Minutes of the Regular Meeting of the Public Building and Site Commission held on Tuesday, September 26, 2017 at the Reed Intermediate School. Chairman Robert Mitchell called the meeting to order at 7:02 p.m.

### **Change Order Review**

**Monthly Report  
to the Public Building and Site Commission  
September 26, 2017**

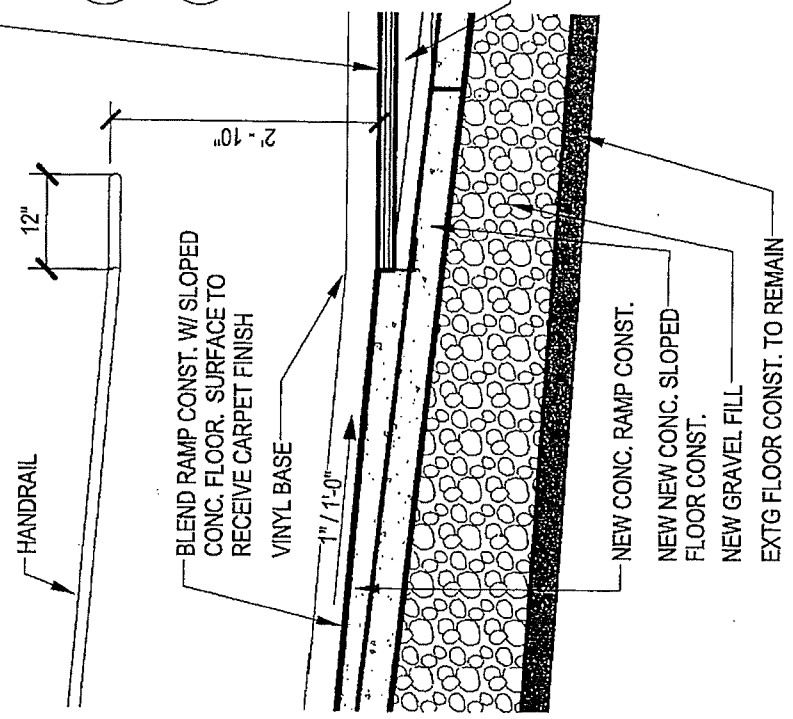
1. **RFI #26:** Plywood panels shall be APA rated; CDX plywood, Exposure 1. w/ span rating of 16". See attached SKA2 – Clarification @ New Framed Floor Const., dated 1/5/17.
2. **RFI #27:** No new louvers in the project. Spec. section 08 90 00 will be deleted.

- NEW FLOOR CONSTRUCTION (TOP TO BOTTOM)**
- CARPET FINISH (NONE AT STAGE)
  - 3/4" CDX PLYWOOD, EXPOSURE 1 (SPAN RATING OF 16", TYP). SCREW DOWN THROUGH BOTTOM LAYER PLYWOOD
  - 5/8" GYPSUM WALL BOARD, GLUE ADHERE TO BOTTOM LAYER OF PLYWOOD
  - 5/8" CDX PLYWOOD, SCREW TO STUD FRAMING

① ELECTRICAL LIGHTING PLAN FLOOR PLAN  
1/8" = 1'-0"

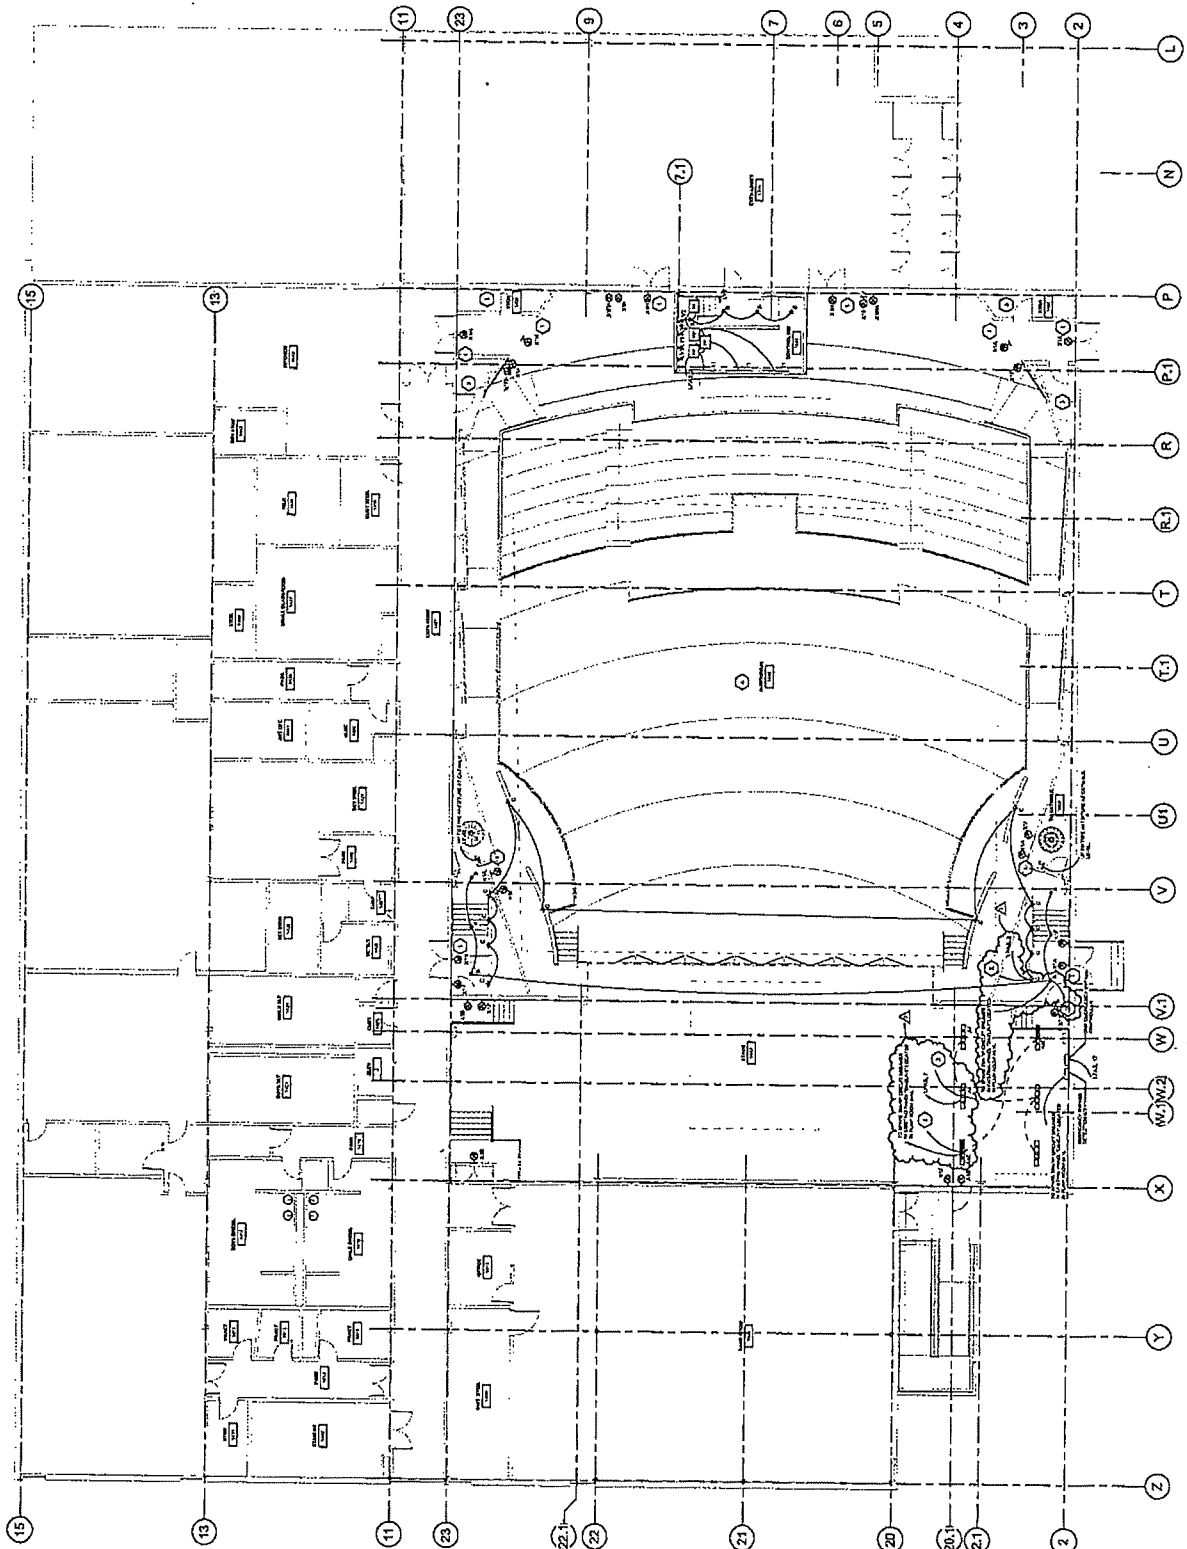
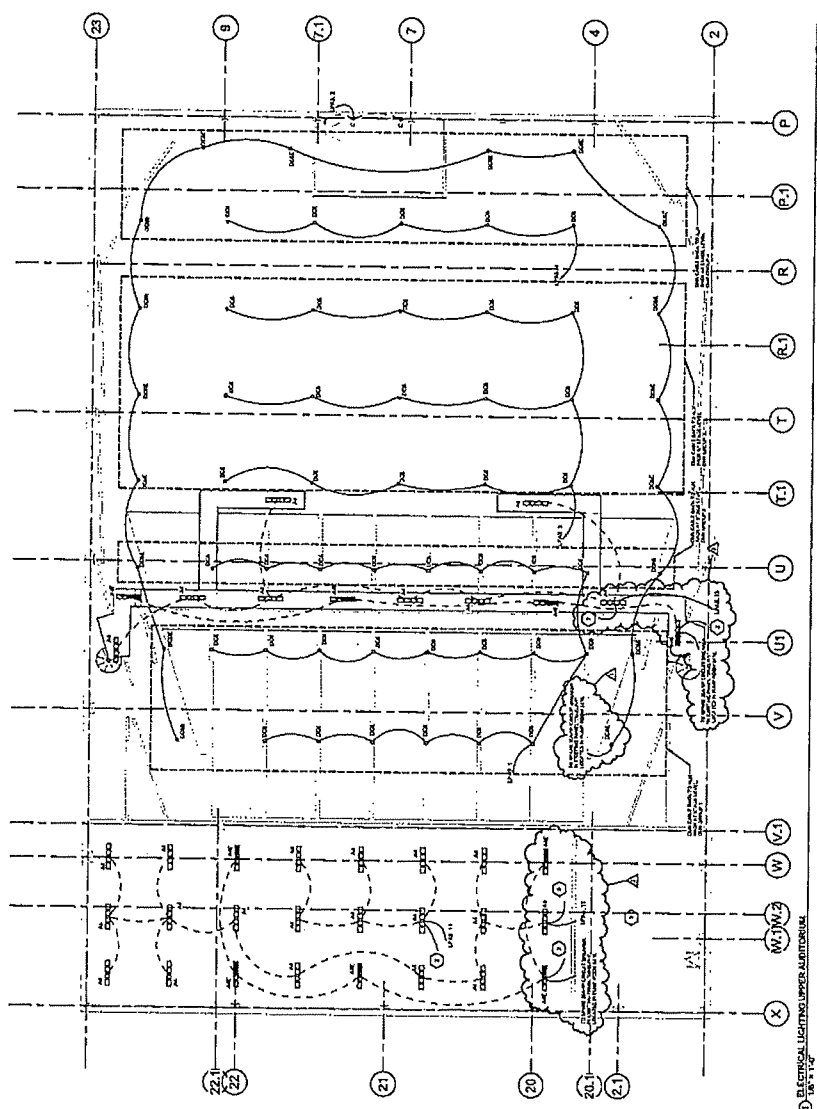
Additional cost of labor and material due to the late addition of Addendum# 1. Eight switched feeds to be routed through DMX controller as note 2 requires on revised drawings EL1.01 and EL1.02.

1. **REPLACE:** XT5.31 – Theater Lighting Details. Add DMX Emergency Bypass Controller and DMX Emergency Detection w/ Manual Restore., Addendum #1 dated 1/5/17
2. **REPLACE:** EL1.01 – Electrical lighting Main Floor Plan, Addendum #1, dated 1/5/17.
3. **REPLACE:** EL1.02 – Electrical Lighting Upper Auditorium, Addendum #1, dated 1/5/17.

DRAWING TITLE: Access Platform South Wall Supports

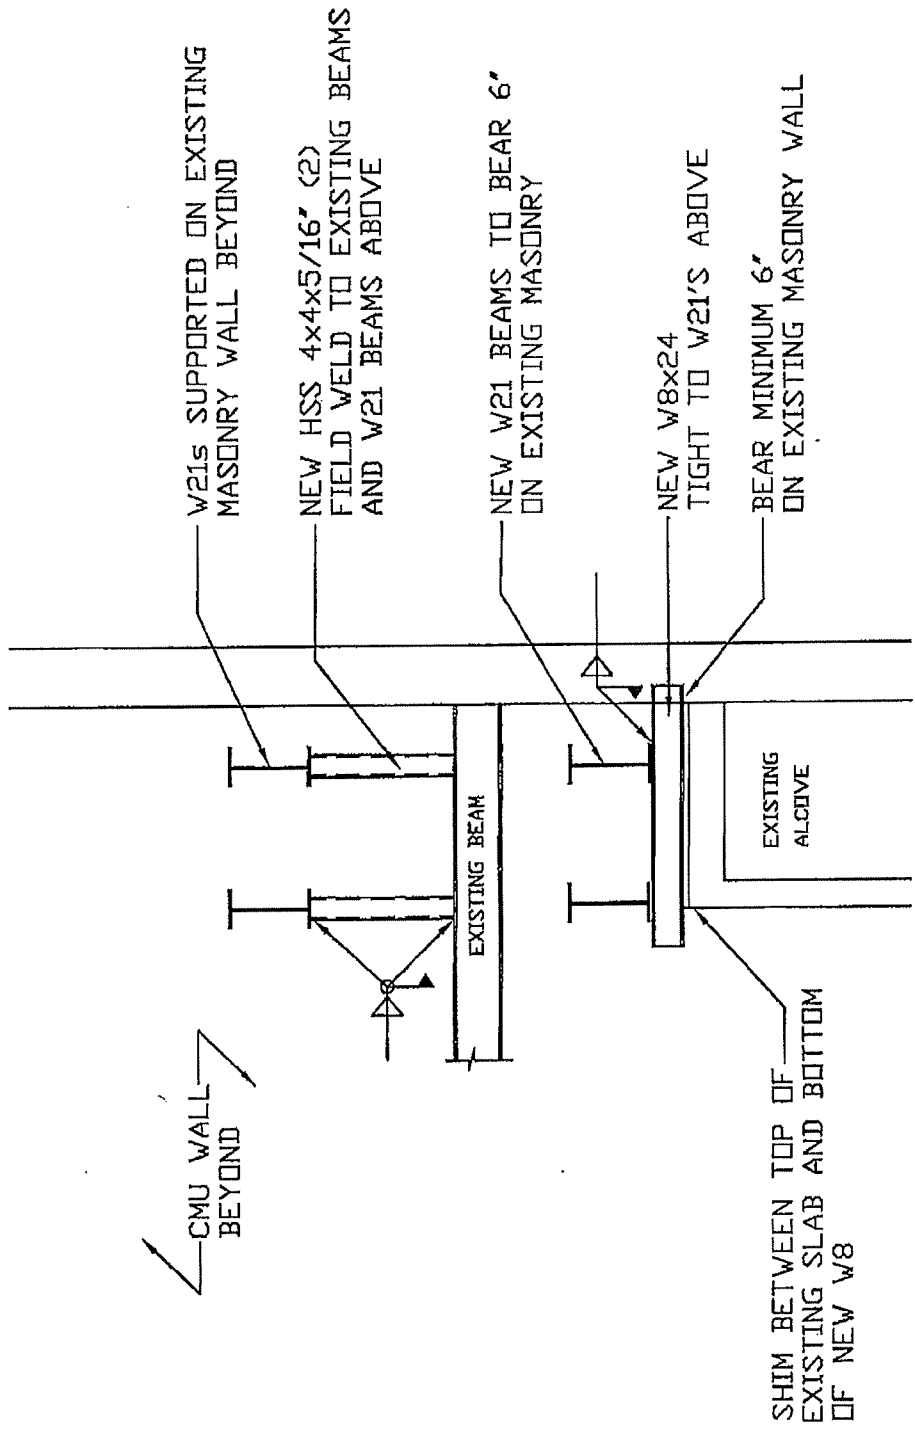
CO #4 Material, Fabrication, and installation of beam and tube supports at catwalk per SK-S2

DRAWING TITLE: Section 5/S3.2 Revision

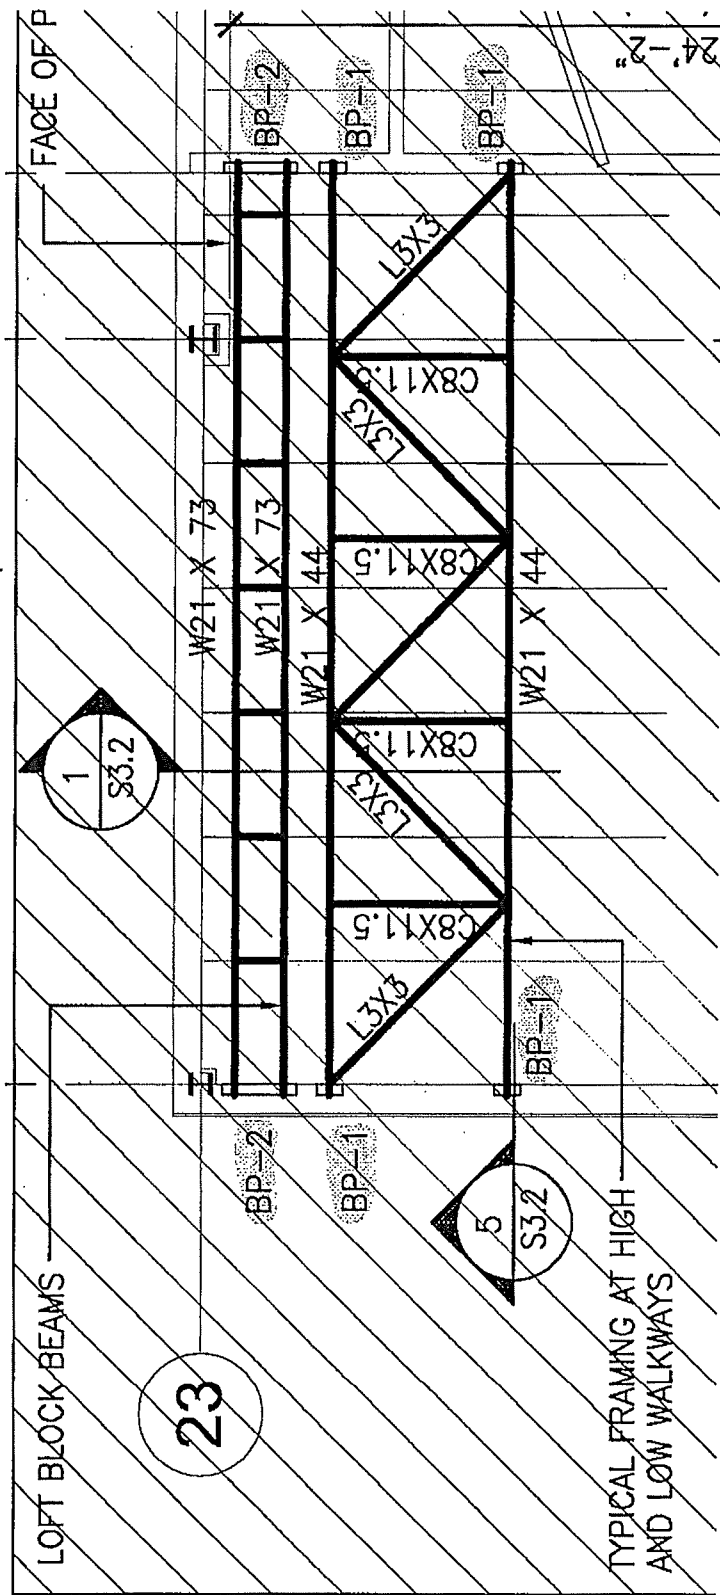
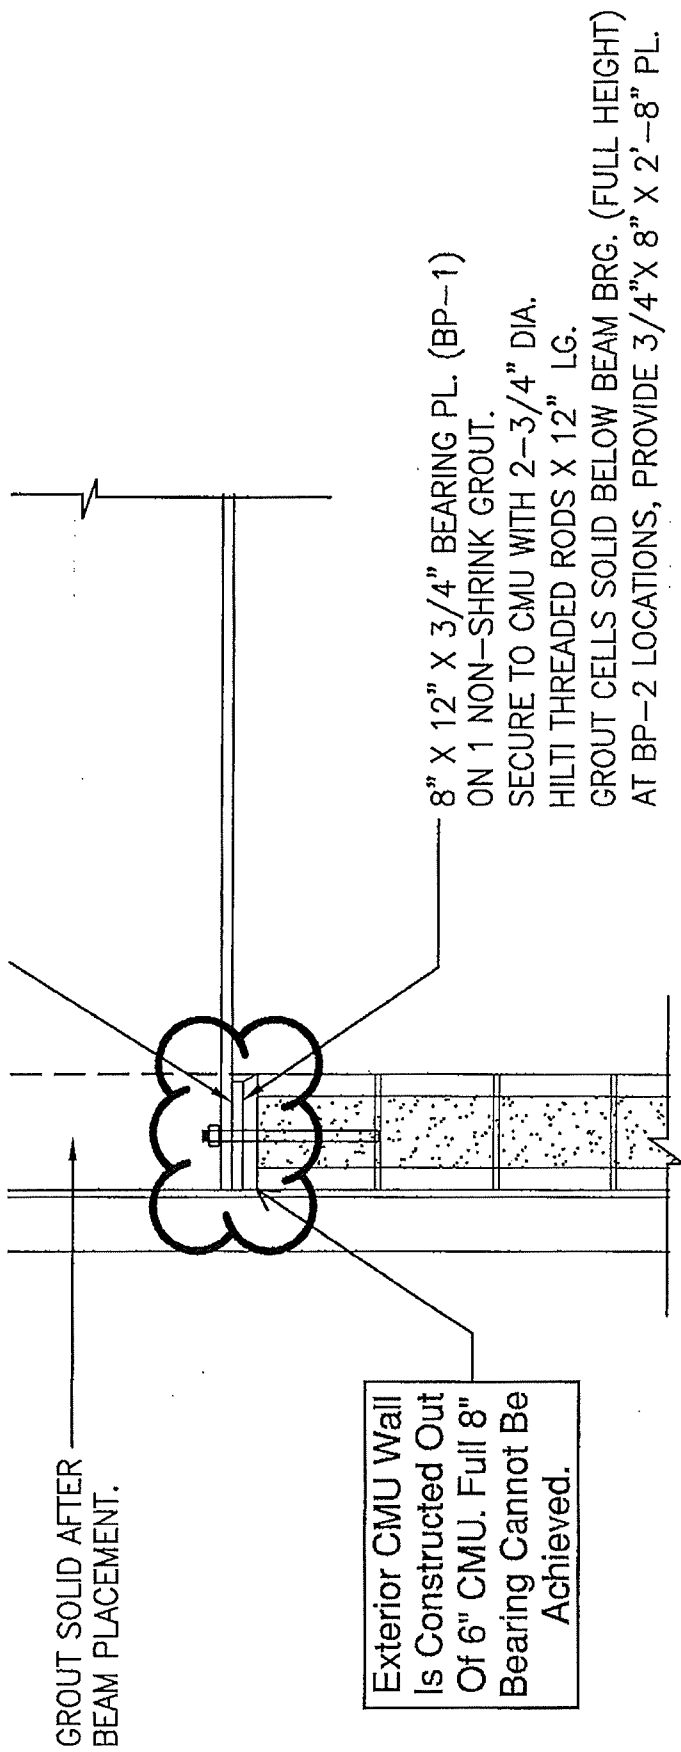
- Sketch SK-S1 indicates to use a 10" bearing plate in lieu of the 8" specified on detail 5/S3.2. Is this required still or can we use the 8" bearing plates that have been fabricated already?

Per detail 5/S3.2 8" bearing plates BP-1 and BP-2 are to be provided for steel to be installed on along the Western portion of the existing stage. After completing selective demolition at the exterior wall along 23 line it was discovered that the existing wall assembly is constructed with 6" block back up. Existing CMU wall along V.1 line has been constructed with 8" block and will be able to achieve full bearing as detailed but plates to be installed along X line will not. Please advise if it is acceptable to install 8" bearing plates on 6" CMU.

8" X 12" X 3/4" BEARING PL. (BP-1)  
 ON 1 NON-SHRINK GROUT.  
 SECURE TO CMU WITH 2-3/4" DIA.  
 HILTI THREADED RODS X 12" LG.  
 GROUT CELLS SOLID BELOW BEAM BRG. (FULL HEIGHT)  
 AT BP-2 LOCATIONS, PROVIDE 3/4" X 8" X 2'-8" PL.

RFI #064

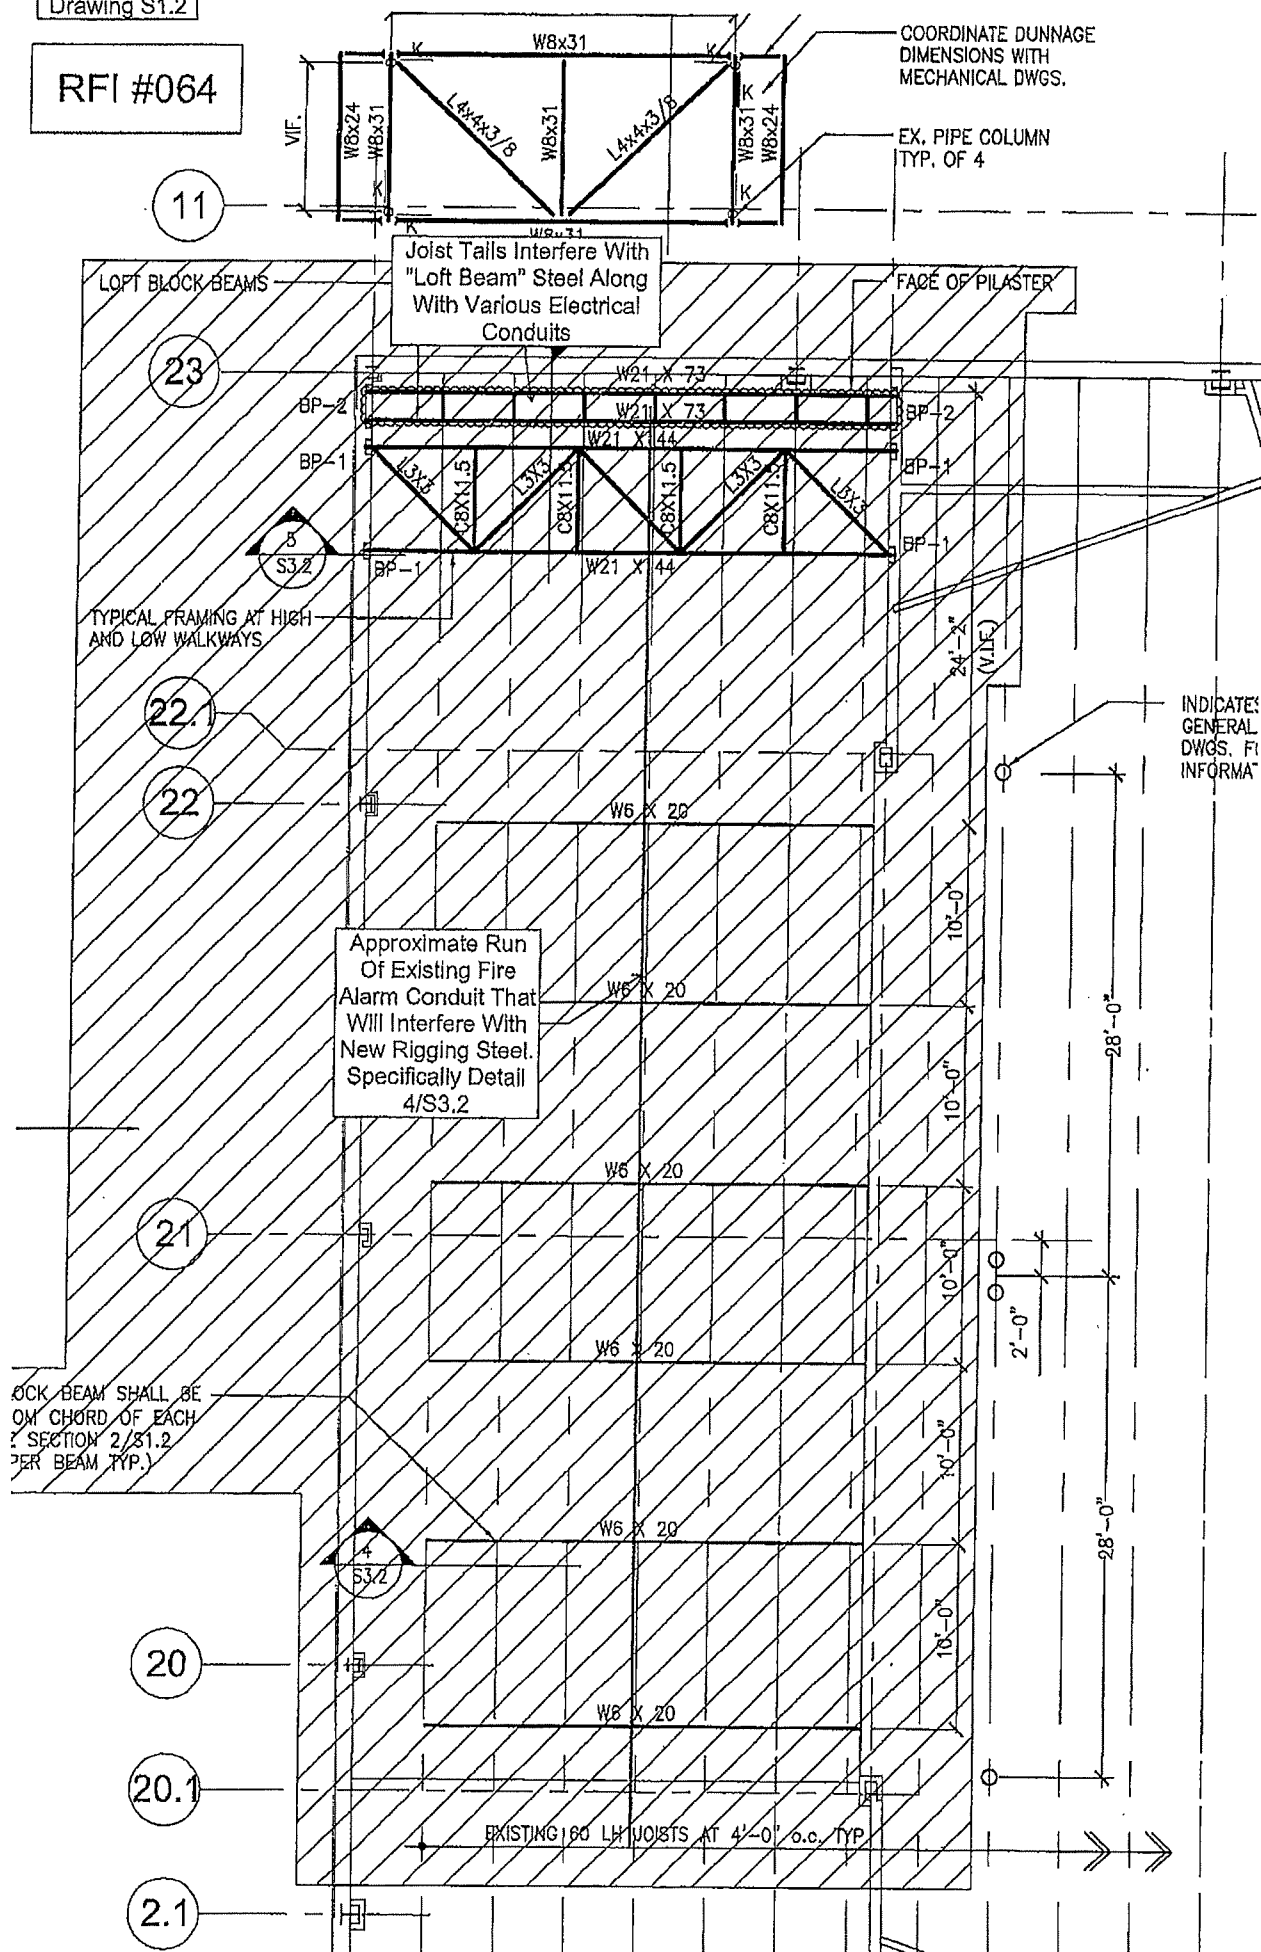
As seen in the attached sketch W6x20 rigging steel including the W21x73 loft block beams cannot be installed as shown on drawings S1.2 and S3.2 due to existing joist and electrical conduit conditions. 1) Various fire alarm conduits (3/4") run East to West along the underside of the existing bar joists interfering with the new W6x20 steel shown to be installed per detail 4/S3.2. Please advise if alarm cable and conduit should be re-routed above joist bottom chord to avoid any potential conflicts with new steel. 2) Joist tails along the Western side of the stage will interfere with new loft block beams shown per detail 1/S3.2. Existing conduit along 23 line in this area will also interfere that supplies AHU-16, AHU-17, RF-1 and fire alarm strobes. Please advise on how to proceed.

Joist bottom chord may be cut back as required. 3" Wide vertical steel plate can be modified but shall remain below the existing diagonal. See enclosed markup. Fire line modification to be answered by others.

PROVIDE L3X5X 5/16" X-BRACE  
AT EACH JOIST LOCATION TYP.

ALIGN BOTTOM OF W21's WITH BOTTOM  
OF W6 LOFT BLOCK BEAMS OVER STAGE  
SEE PLAN FOR LOCATIONS.
